ADDENDUM NO. 1

DATE: March 27, 2020

FROM: Baxter & Woodman, Inc., Consulting Engineers

VILLAGE OF HOFFMAN ESTATES, ILLINOIS  
CHIPPENDALE LIFT STATION REHABILITATION

**M-2**

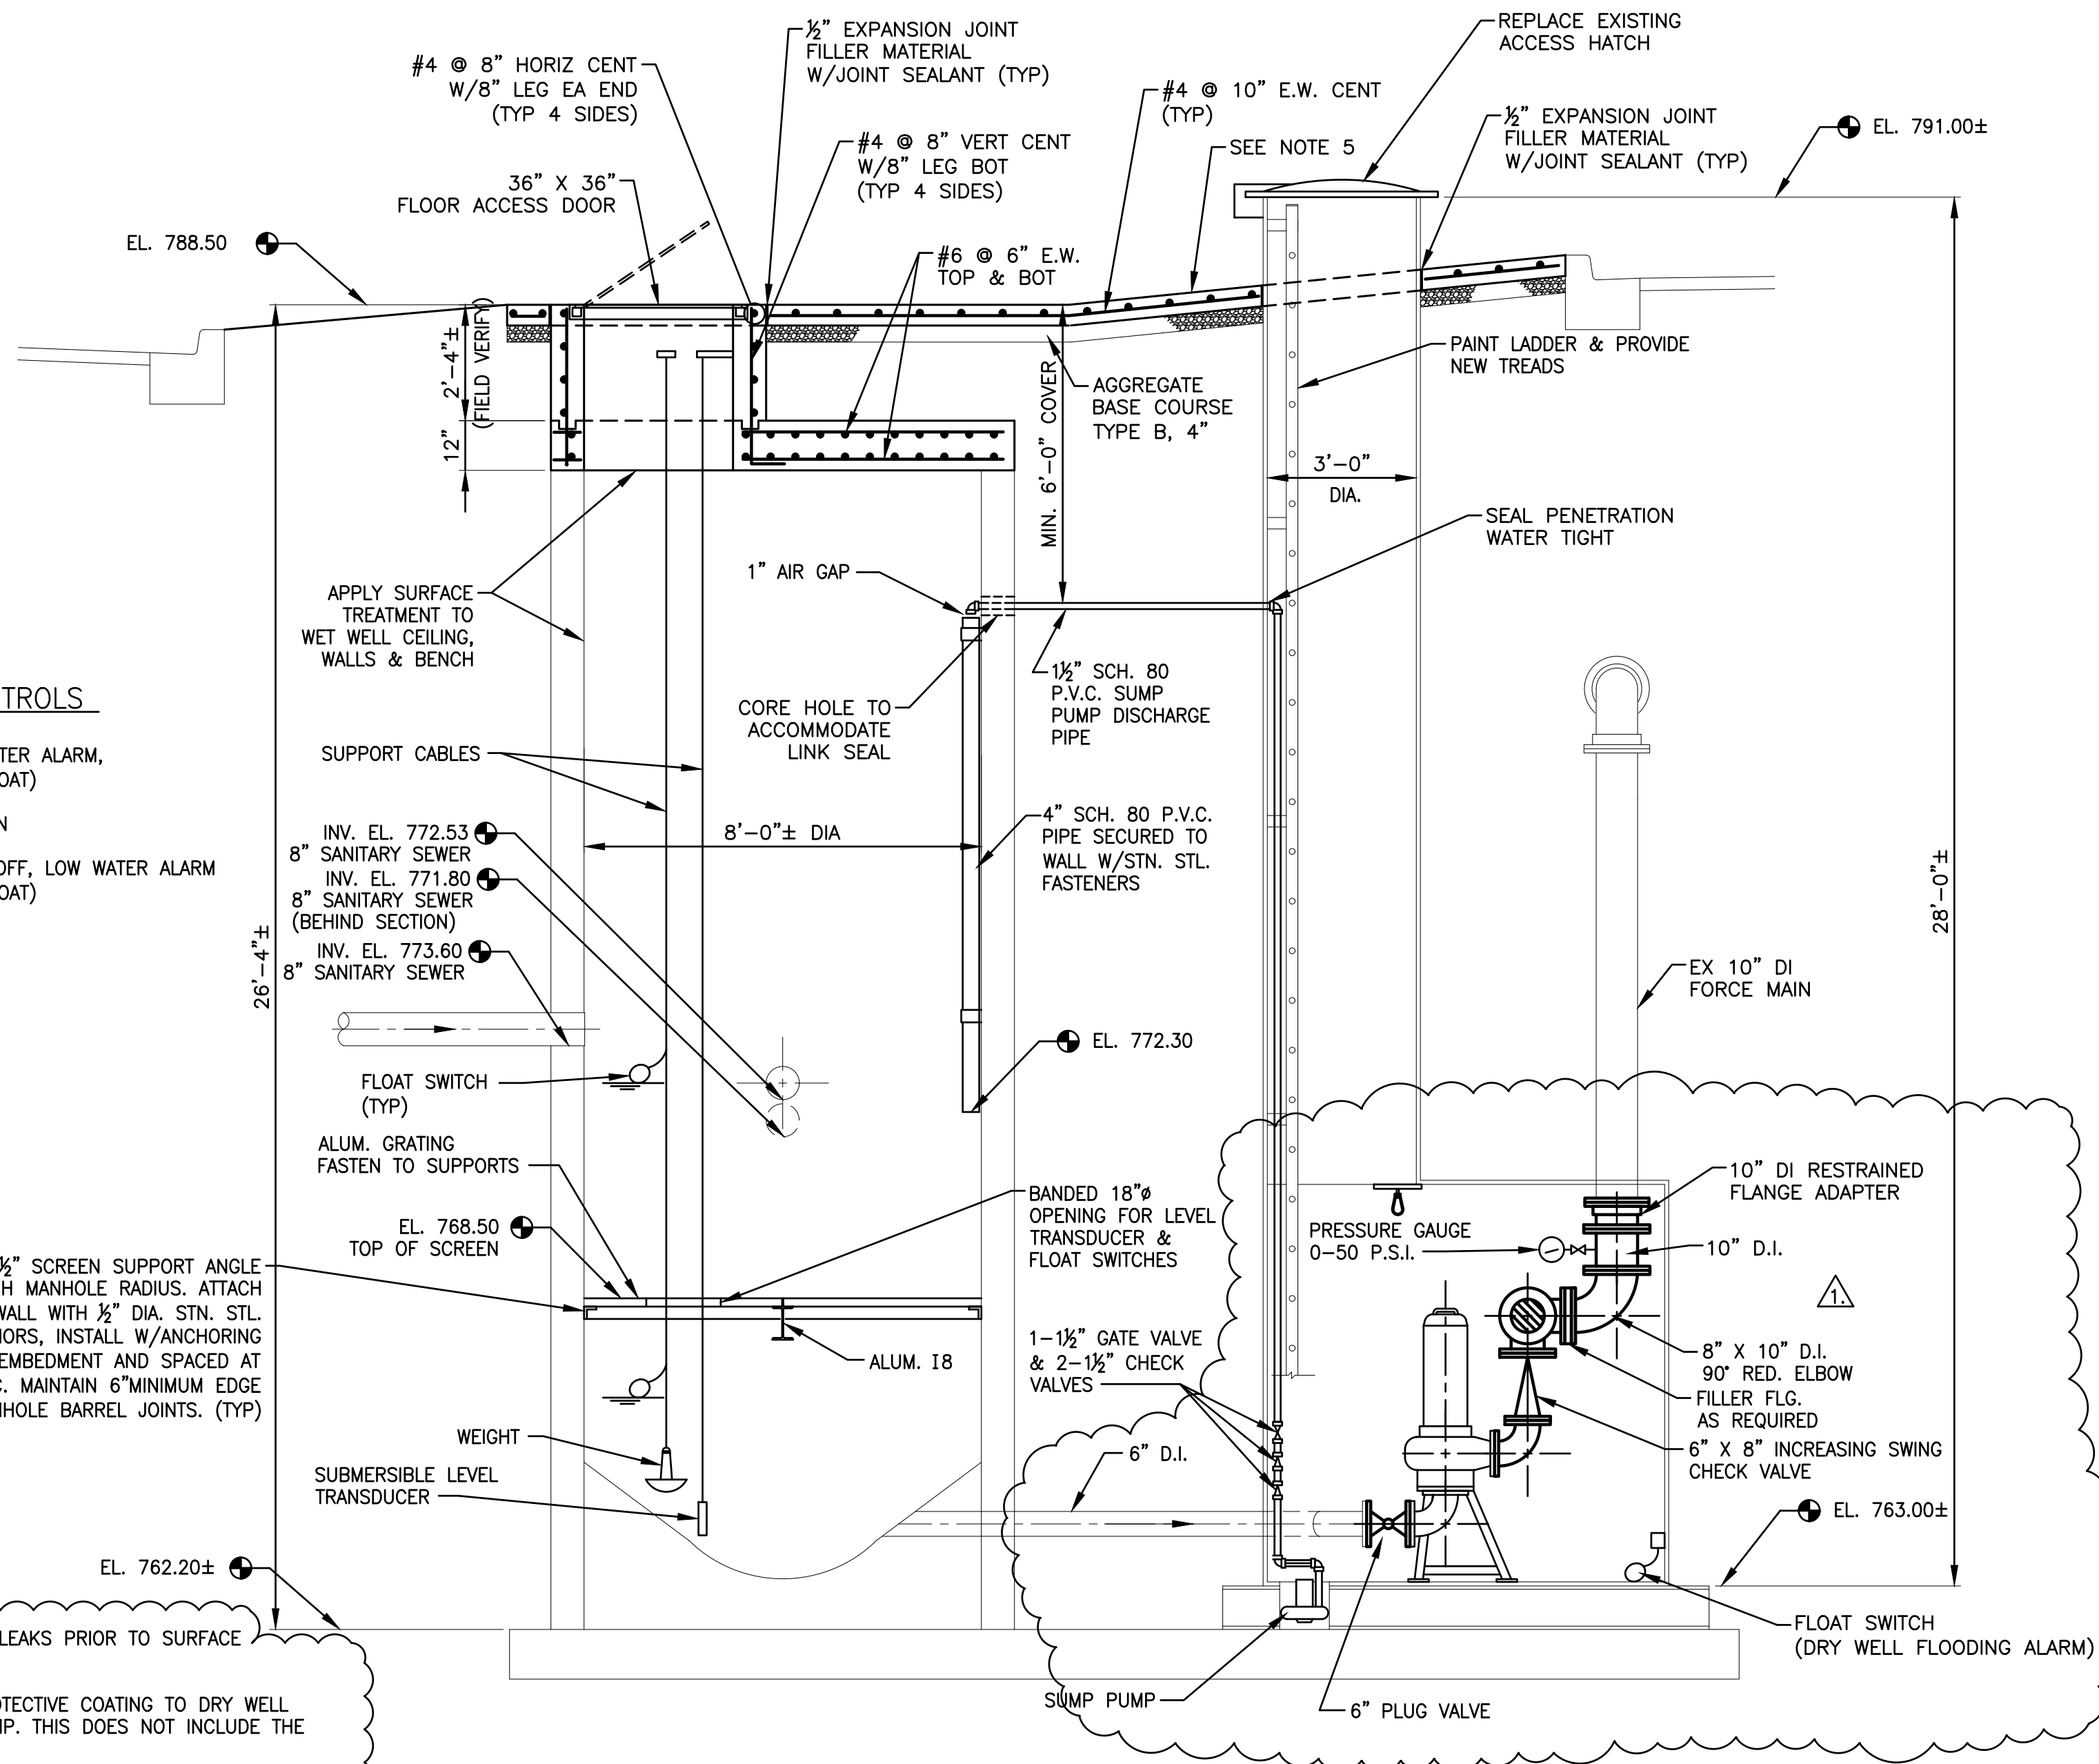
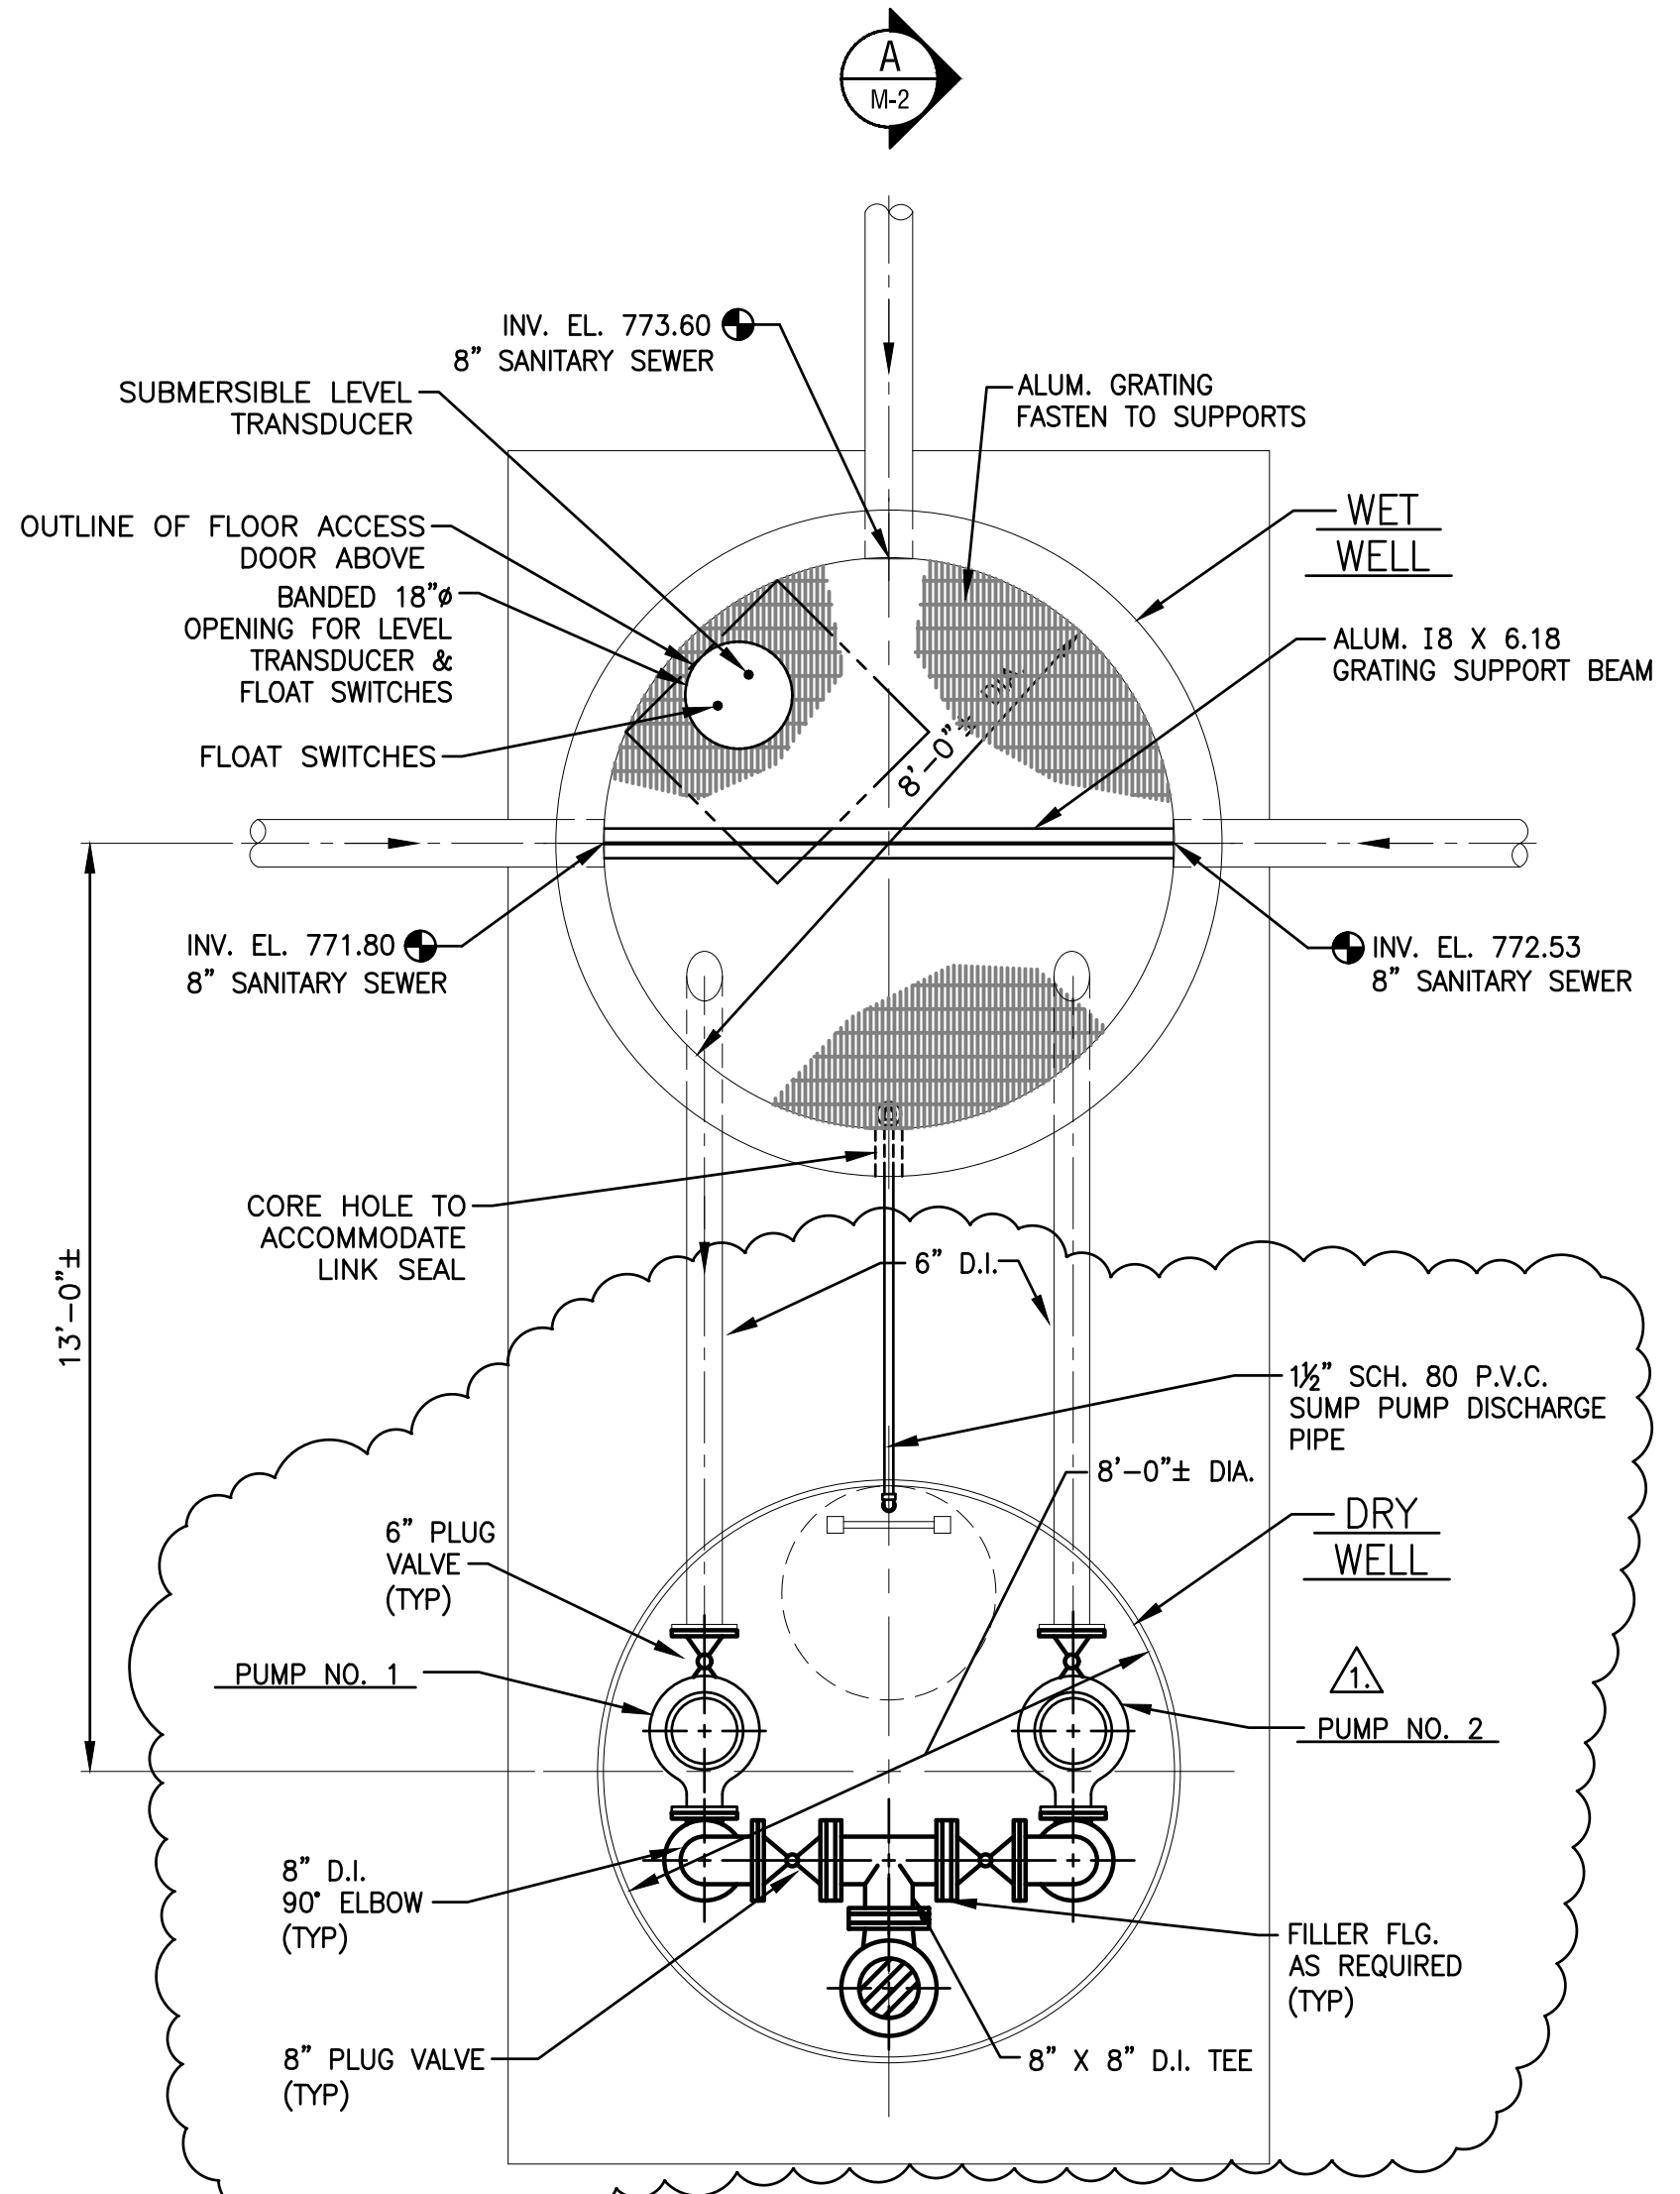
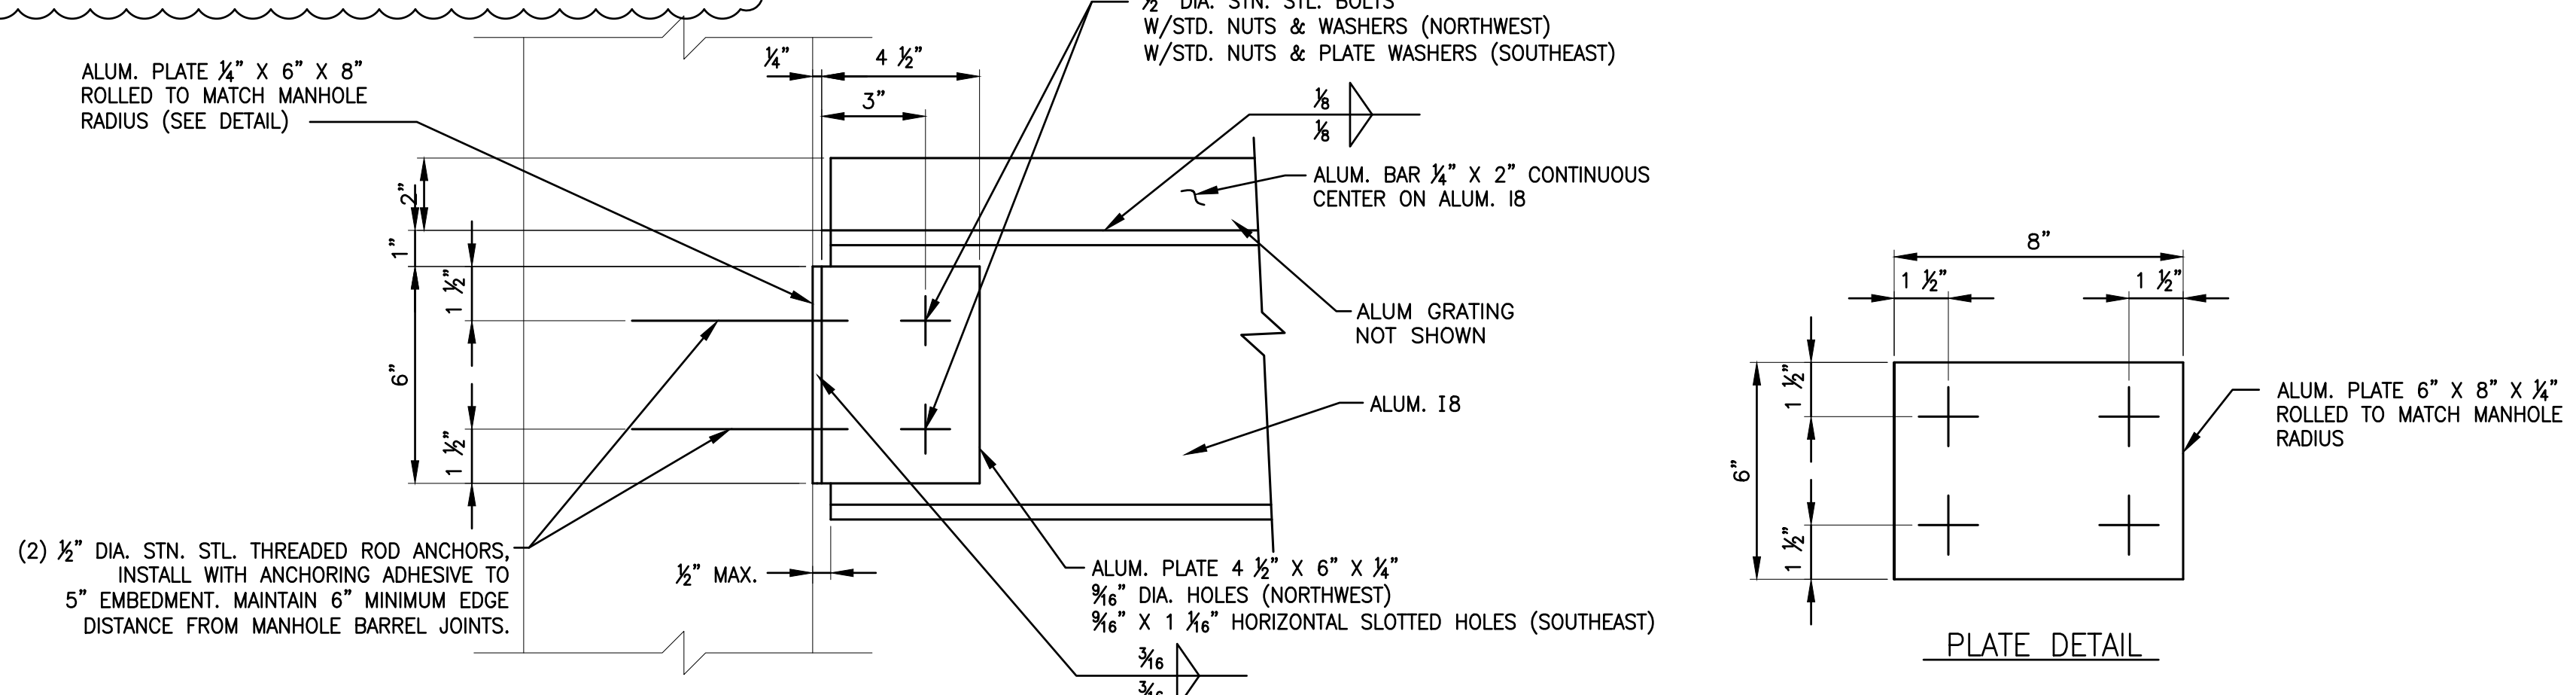
- C. Delete Sheets M-1 and M-2 in their entirety, and insert attached Sheets M-1 and M-2, revision dated March 26, 2020 in lieu thereof.

Piping and pump layouts for the existing (demolition) drawing and for the proposed pumps, piping, valves, and fittings drawing have been revised. In addition, the Notes on Sheet M-2 were revised.
